Our Case Number: ABP-317742-23

Re: BusConnects Bray to City Centre Core Bus Corridor Scheme

RE: OBSERVATION ON STRATEGIC INFRASTRUCTURE DEVELOPMENT ABP REF: 317742-23.

Figure 8 - Revised forecourt arrangement post construction (Source: NTA, 2024)

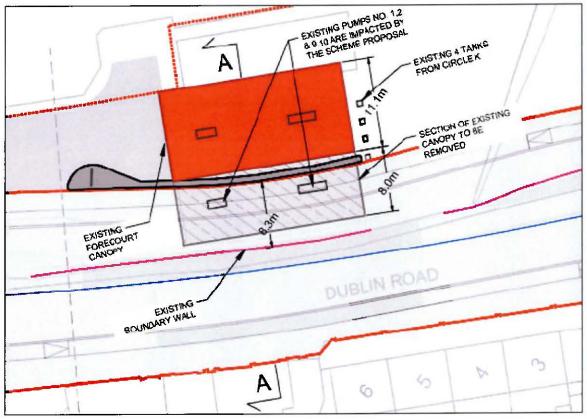
The submission highlights that Circle K will re-gain possession of the remaining site, which is proposed to be reconfigured, re-instated with pumps re-commissioned and operational as a petrol station, on completion of the BusConnects construction works. A significant amount of work is required prior to the facility being returned to our client. As shown in Figure 8 above, the scope of the service station will be greatly reduced.

The General Arrangement drawing prepared by the NTA and shown in Figure 8 above along with the respective commentary on same does not appear to take account of the potential interrelated knock-on effects as a result of the reprofiling of the forecourt fuel area, the removal of parking spaces in the site and the loss of facilities including the existing car wash. This has been highlighted in the accompanying technical reports from our client's appointed architects and engineers.

In particular, the revised setback proposed, which greatly reduces the size of the forecourt will create an access issue for passing motorists and HGV fuel tanker deliveries. The swept path analysis prepared by the NTA does not account for where HGV fuel tankers will have to park within the forecourt when fuel deliveries are taking place, nor does the submission account for how this will affect passing motorists and customers as they access/egress the site.

Figure 4: Scheme Cross Sections at Donnybrook and Leeson St. Lower

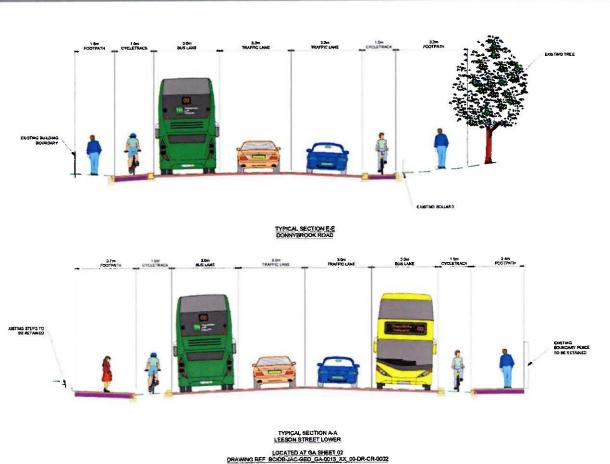
However on inspection of the various scheme drawings it is noted that this "optimum required" is compromised in certain locations such as DonnyBrook Road, where a Bus lane is dropped or Leeson St. Upper where the cycle track widths are reduced. See Figure 4 below.

Given the long term viability for the service station being under severe pressure by this scheme proposal Circle K would urge the NTA to reconsider the "optimum requirement" at this location on the Dublin Road in Bray.

Figure 8 - Revised forecourt arrangement post construction (Source: NTA, 2024)

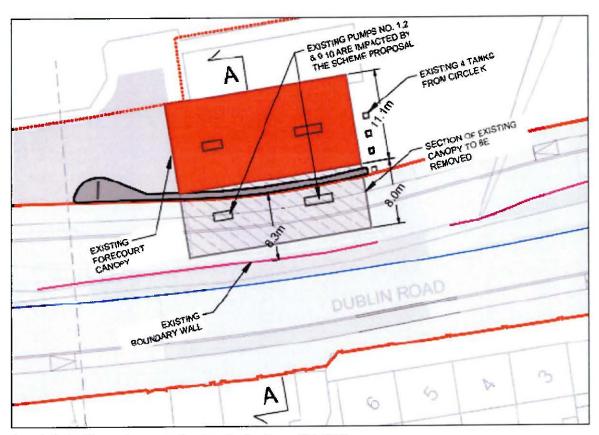
The submission highlights that Circle K will re-gain possession of the remaining site, which is proposed to be reconfigured, re-instated with pumps re-commissioned and operational as a petrol station, on completion of the BusConnects construction works. A significant amount of work is required prior to the facility being returned to our client. As shown in Figure 8 above, the scope of the service station will be greatly reduced.

The General Arrangement drawing prepared by the NTA and shown in Figure 8 above along with the respective commentary on same does not appear to take account of the potential interrelated knock-on effects as a result of the reprofiling of the forecourt fuel area, the removal of parking spaces in the site and the loss of facilities including the existing car wash. This has been highlighted in the accompanying technical reports from our client's appointed architects and engineers.

In particular, the revised setback proposed, which greatly reduces the size of the forecourt will create an access issue for passing motorists and HGV fuel tanker deliveries. The swept path analysis prepared by the NTA does not account for where HGV fuel tankers will have to park within the forecourt when fuel deliveries are taking place, nor does the submission account for how this will affect passing motorists and customers as they access/egress the site.

Figure 4: Scheme Cross Sections at Donnybrook and Leeson St. Lower

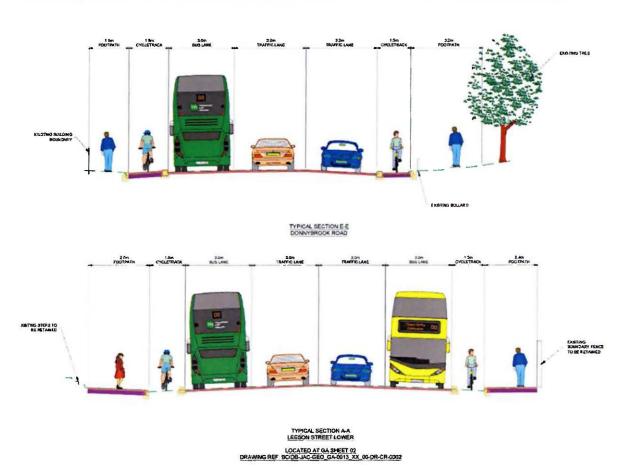
However on inspection of the various scheme drawings it is noted that this "optimum required" is compromised in certain locations such as DonnyBrook Road, where a Bus lane is dropped or Leeson St. Upper where the cycle track widths are reduced. See Figure 4 below.

Given the long term viability for the service station being under severe pressure by this scheme proposal Circle K would urge the NTA to reconsider the "optimum requirement" at this location on the Dublin Road in Bray.
